Request for Additional Information No. 103, Supplement 1

U. S. EPR Standard Design Certification

Docket No. 52-020

SRP Section: 16 - Technical Specifications

Figure 16-193-1

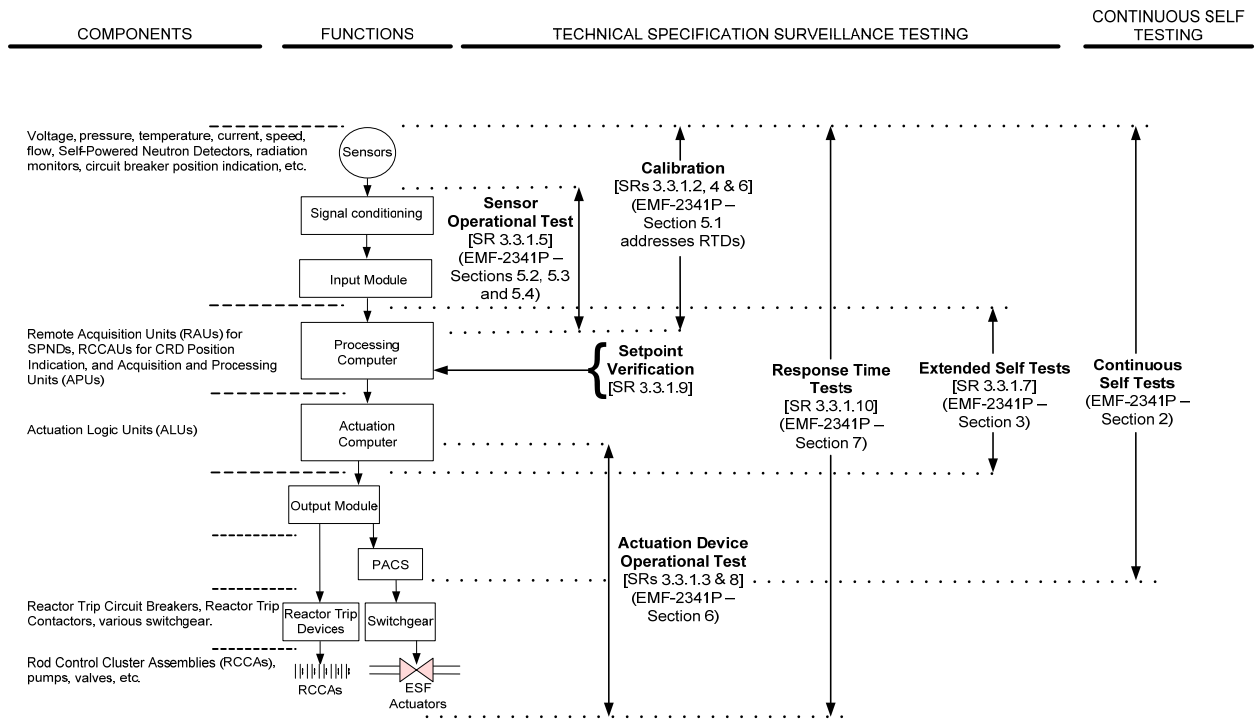
Provide additional information in the EPR Bases to describe the overall approach to Surveillance Requirement Testing with respect to Protection System Instrumentation. Include an explanation as to how that approach ensures that all Reactor Trip and ESFAS functions in the EPR GTS, Table 3.3.1-2, are adequately tested. Provide a figure which depicts a "Summary of Protection System Testing."

Additional information is needed that describes the approach to PS Surveillance Requirement Testing with respect to the following specifics:

Figure 16-193-1 summarizes the testing of the U.S. EPR Protection System, which provides a correlation between specific sections of Siemens Topical Report EMF-2341(P), "Generic Strategy for Periodic Surveillance Testing of TELEPERM XS Systems in U.S. Nuclear Generating Stations," and the surveillance testing specified in U.S. EPR FSAR Tier 2, Chapter 16, Technical Specifications Section 3.3.1 "Protection System (PS)". Also refer to the response to RAI 122, Question 16-243, for a discussion of the differences between definitions used in the Standard Technical Specifications for Westinghouse Plants (NUREG-1431) and the U.S. EPR Generic Technical Specifications.

- a. There is no fundamental difference between a function-based surveillance testing approach and a component-based approach. Since a function is performed by components, a component-based approach only specifies an additional level of detail by defining which specific surveillances apply to which specific components. The U.S. EPR FSAR Tier 2, Technical Specifications Section 3.3.1 are grouped into a set of four functional components (See Technical Specifications Bases Page B 3.3.1-4):
 - Sensors (which include the associated signal conditioning),
 - Manual actuation switches,
 - Signal processors, and
 - Actuation devices.

- b. Response time testing will be added to U.S. EPR FSAR Tier 2, Chapter 16, Technical Specifications Section 1.1 "Definitions," Section 3.3.1 "Protection System (PS)," and Technical Specification Bases Section B 3.3.1 "Protection System (PS)".
